CONTRACT CHANGE ORDER NO. 192

SAN FRANCISCO OAKLAND BAY BRIDGE
EAST SPAN SEISMIC SAFETY PROJECT

OAKLAND APPROACH STRUCTURES CLEANUP ITEMS

BIKEPATH RAILING DIVIDER

RAILING DIVIDER DETAIL

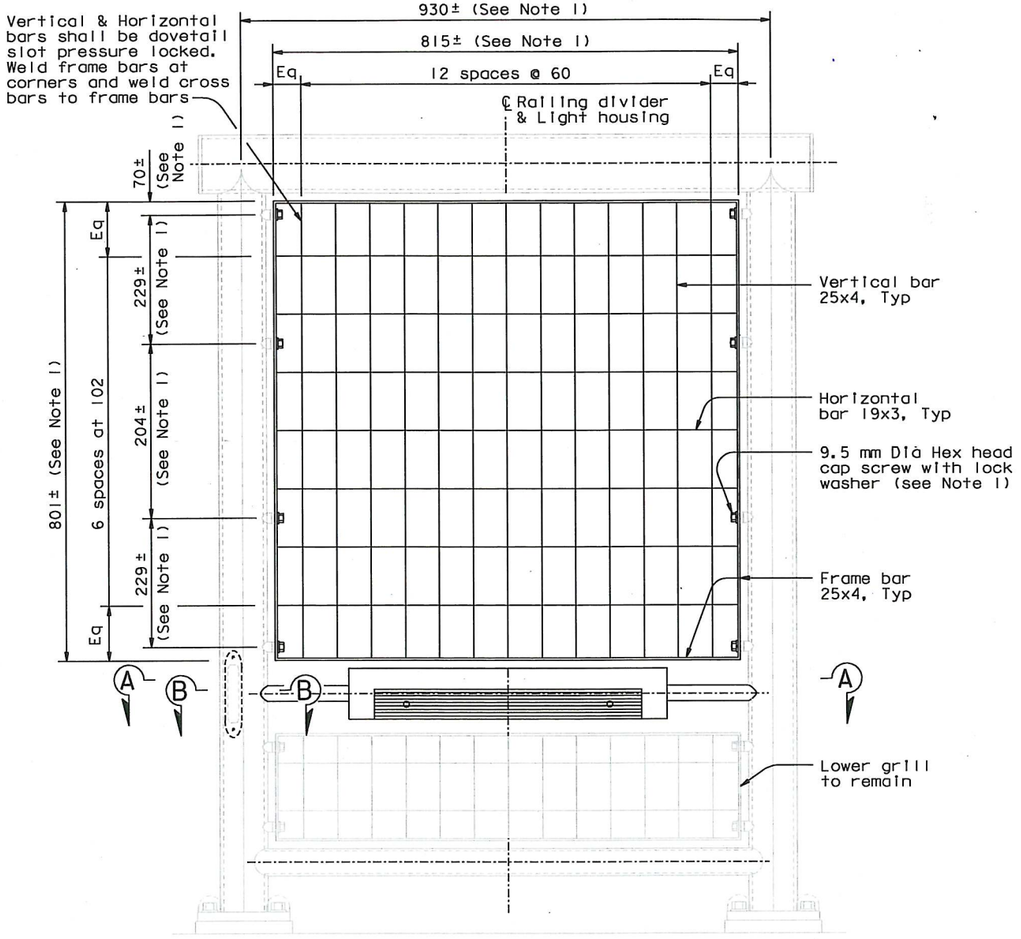
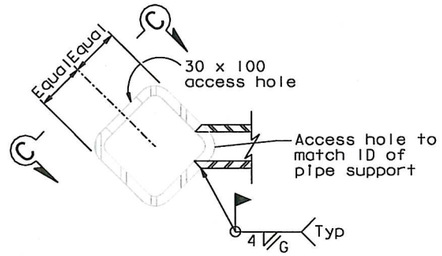
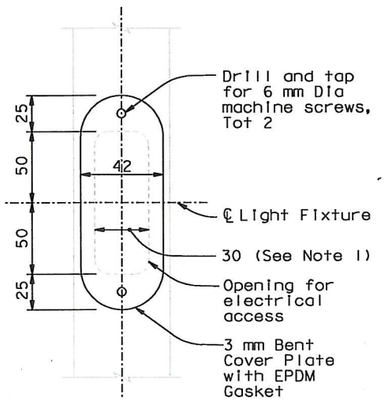
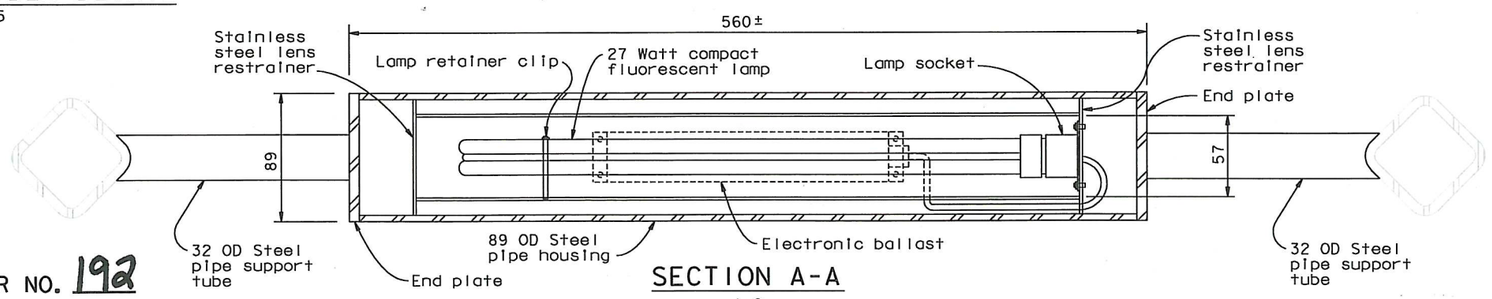
RAILING DIVIDER MODIFICATION PROCEDURE:

1. Remove and Install new upper railing grill.
2. Remove and Install new light housing.
3. Drill and tap holes, Install new access hole cover plates.
4. Galvanized surfaces shall be repaired. Areas with damaged paint or with no paint shall be cleaned and painted.

HANDRAIL ADJUSTABILITY DETAILS

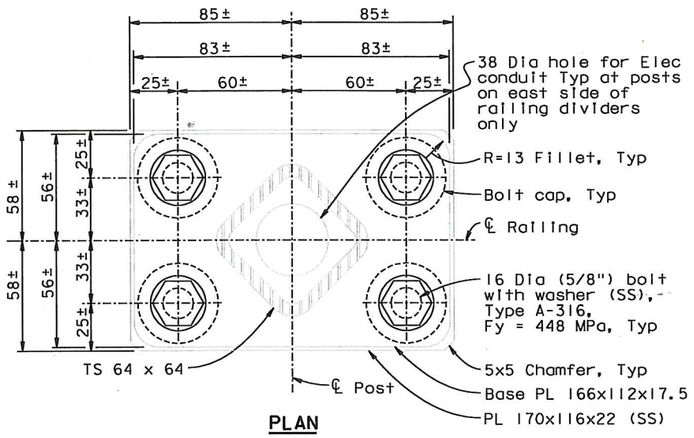
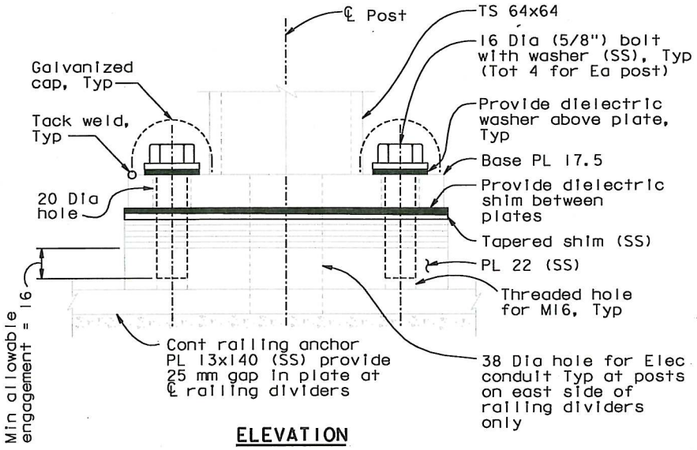
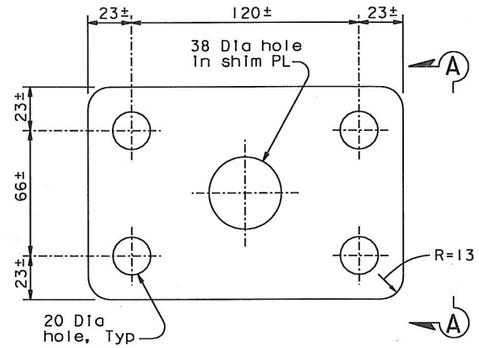
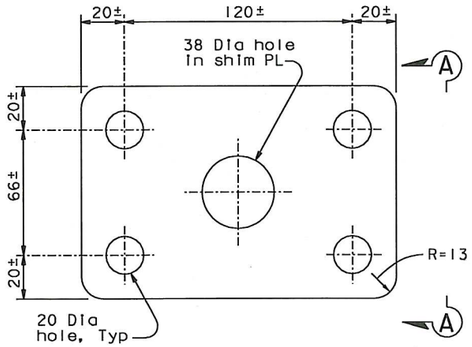
BOLT AND SHIM REPLACEMENT PROCEDURE:

1. Remove and discard bolt, cap and washer.
2. Remove and discard the dielectric material above and below the base plate.
3. Clean out and dry the threaded anchor hole.
4. If needed, replace the top most existing stainless steel standard shim with a new stainless steel tapered shim of thickness and taper necessary to properly align top rail of bikepath railing.
5. Install dielectric shim (UHMW) below base plate.
6. Install dielectric washer (UHMW) above base plate.
7. Insert new bolt, domed cap and washer. The length of the bolt shall be such that the engagement length into the PL 22 is a minimum of 16 mm.
8. Bolts shall be tightened to "Snug Tight Plus 1/4 Turn". Bolts shall be installed with thread locking compound.

1. Bolt and shim replacement shall be performed on all railing divider posts and all standard railing posts on the North and South side bikepath railing.
2. The Contractor shall verify all controlling field dimensions before ordering or fabrication any material or performing any work that might thereby be affected.
3. The alternate shim dimensions shall be used as directed by the Engineer.
